Re: S/D 89-19 - AMBURGEY 2ND ADDITION

STAFF REPORT  
(Final Plat)

CASE NUMBER: S/D 89-19 - AMBURGEY 2ND ADDITION

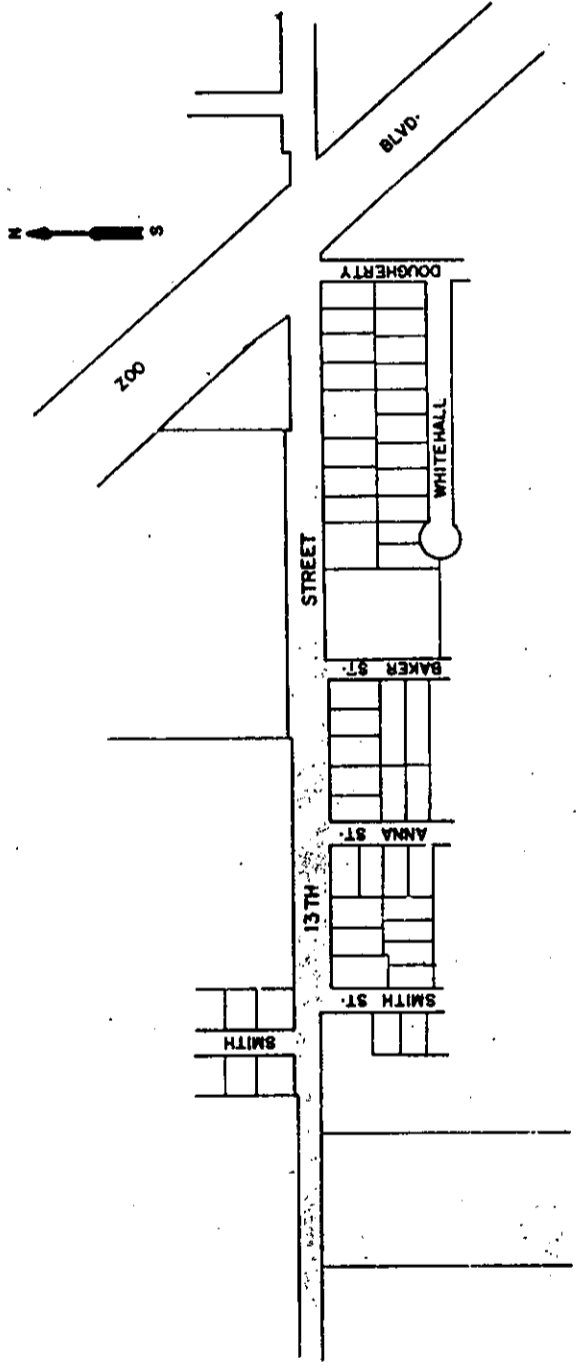
- C. The applicant shall obtain, by separate instrument, the 4.5 foot wide off-site utility easement required adjacent to the south line of this plat. This instrument shall be submitted to the Planning Department for processing.

- D. The applicant is advised that this portion of 13th Street North is a part of the designated collector street system. The final plat tracing may indicate the platting of 35-foot half-street right-of-way.

- E. Should the applicant choose to dedicate only the 5-foot of additional half-street right-of-way then; approval of this plat will require a waiver of the lot depth to width ratio of the Subdivision Regulations. The Subdivision Regulations state that, "the maximum depth of all residential lots shall not exceed 2-1/2 time the width thereof."

- F. The applicant shall submit an avigational easement covering all of subject plat and a restrictive covenant assuring that adequate construction methods will be used to minimize the effects of noise pollution in the habitable structures constructed on subject property.

- G. Perimeter closure computations shall be submitted with the final plat tracing. Section 5-101(c).
- H. The applicant shall install or guarantee the installation of all utilities and facilities which are applicable and described in Article 8 of the MAPC Subdivision Regulations.

- K. Recording of the plat within 30 days after approval by the City Council.
- L. The representatives from the utility companies should be prepared to comment on the need for utility easements to be platted on this property.
- M. The representative from the City Engineer's office should be prepared to comment on the status of the applicant's drainage plan. Specifically, are any drainage guarantees required with the platting of this property? Also, would the dedication of only 5-feet of additional street right-of-way conflict with any projects Engineering has for 13th Street?

- A. The applicant shall obtain, by separate instrument, the 4.5 foot wide off-site utility easement required adjacent to the south line of this plat. This instrument shall be submitted to the Planning Department for processing.

- B. The applicant is advised that this portion of 13th Street North is a part of the designated collector street system. The final plat tracing shall indicate the platting of 35-foot half-street right-of-way.

- C. Approval of this plat will require a waiver of the lot depth to width ratio of the Subdivision Regulations. The Subdivision Regulations state that, "the maximum depth of all residential lots shall not exceed 2-1/2 time the width thereof."
